# Product Change Notification

PCN #: 10D-2021

DATE: 12<sup>th</sup> October 2021

## 1 PRODUCTS AFFECTED – TOP LEVEL PART NUMBERS

#### ST60-SIPT

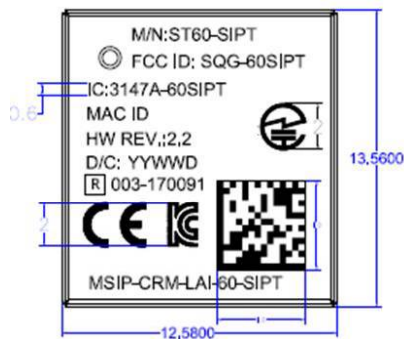
- Date code rule change to SSSYYWWD from YYWW. See the drawing in Section 5 below
- Add UKCA logo to product label (laser etching to RF shield of SIP).

**ST60-SIPT**

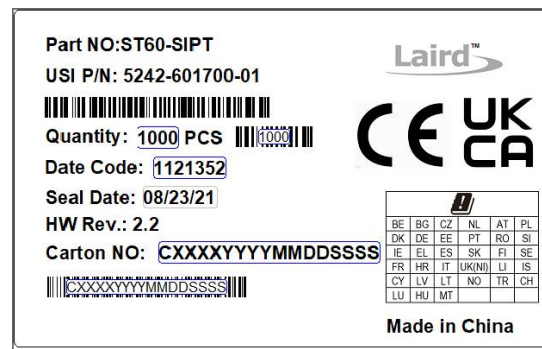
- Date code rule change and add UKCA logo and Pictogram to carton label
